**Manitoba Clean Environment Commission
Hearing for the Vivian Silica Sand Extraction Project (Project)**

Sio Silica Corporation (SSC) Responses to Information Requests (IRs) Round No. 1

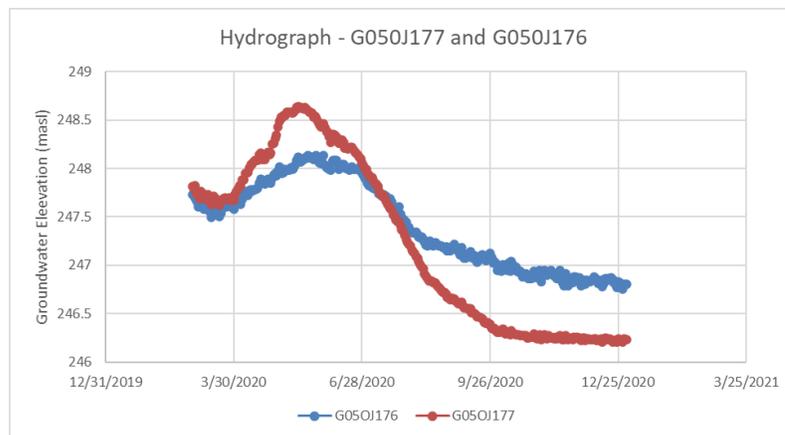
a) Please describe what measures were undertaken to ensure that these piezometers provided reliable data prior to and after final installation.

Response: a) The vibrating wire piezometers were installed by hydrogeologists that have significant experience working with VWPs and similar instrumentation to depths approaching 1,000 m. They are familiar with calibration and installation protocols and have received training and mentoring from the manufacturer on several occasions over the past 15 to 20 years. The instruments are factory calibrated near Maple Ridge, British Columbia, and were shipped overland in boxes with the instruments protected in foam and bubble wrap. Upon arrival, the instruments were inspected by trained personnel and confirmed to be in good condition. As described in Method Section 3.4.4 of the Hydrogeology and Geochemistry Assessment, *“Prior to installation, VWP sensor membranes were saturated by submerging them in a pail of water for more than 24 hours in an inverted position. Once saturated, initial readings were taken with no load applied immediately before installation. These initial readings were used to apply correction factors to the post-installation readings”*.

As part of this exercise, the instrument is typically raised and lowered within a water-filled vessel to confirm it is able to capture changes in the measured hydraulic head that are consistent with the range of movement of the sensor. During installation, *“VWP sensors were secured to one-inch diameter Schedule 80 PVC tremmie pipe and lowered into the borehole until the target depth was reached”*. Combined with the subsequent geodetic survey of each borehole, this allowed for determination of the elevation of the sensor. Care was taken to avoid over pressuring the sensors during grouting of each borehole following industry-standard methods. *“The four VWP cables were connected to the DT2055B multichannel datalogger furnished by RST Instruments and programed to record data at 30 second intervals.”* Following installation, the equations in each datalogger were validated against information provided in calibration sheets from the manufacturer, and the pressure measurements were converted to geodetic groundwater elevations. The resultant groundwater elevations were compared to those observed in the borehole prior to installation of VWPs and in nearby wells and at the resultant groundwater elevations were judged to be reasonable. VWP installation records and RST calibration records were also provided in Appendix D of the Hydrogeology and Geochemistry Assessment.
